Washington Environmental Council

August 16, 2021

Comments on Draft Puget Sound Nutrient General Permit

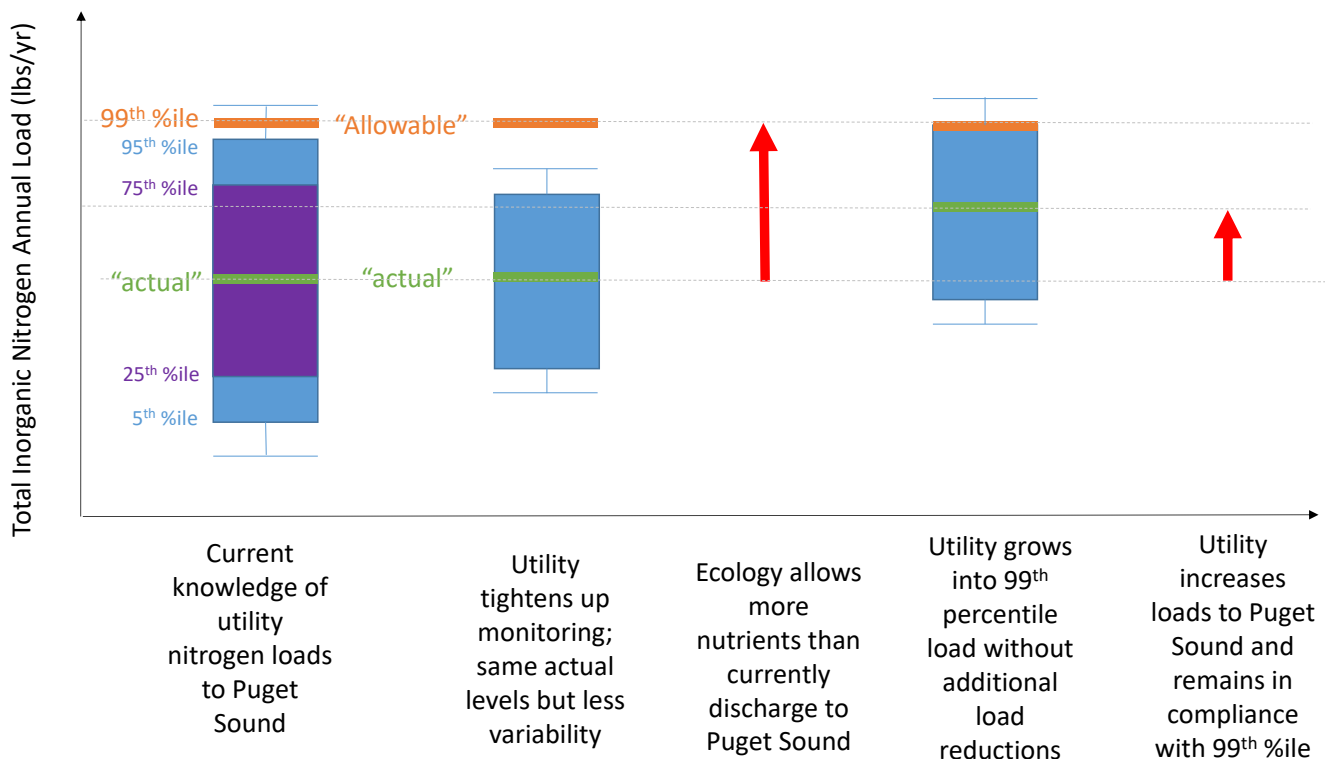
The nutrient load action levels remain far too permissive. Ecology set these at the 99th percentile upper confidence limit of current loads, even though no one advocated for this permissive of a statistic during Advisory Committee deliberations. WEC and others specifically recommended against the 99th percentile. This inadvertently allows tons of nitrogen pollution above safe levels for Puget Sound (see figure below) to protect a number that simply triggers planning activities.

We recommend that action levels be based on 75th or 90th percentiles of nitrogen load estimates by each plant.

Ecology used a statistical technique to estimate current loads from individual plants, then applied an unnecessarily permissive 99th percentile upper confidence limit for the single values listed in the Draft Permit. As described above, that inadvertently increases the allowable load to Puget Sound (see figure below). Because an overly permissive statistic was used, we are concerned that when individual plants report their annual loads as lbs/year as a single number, those are highly likely to be under the 99th percentile simply as a matter of statistics. We recommend that Ecology require plants to report annual loads as 5th, 10th, 50th, 90th, and 95th percentile load estimates rather than a single number. Dischargers have stated that they see high uncertainty in the load estimates, and reporting the ranges will improve the information available annually to assess uncertainty.
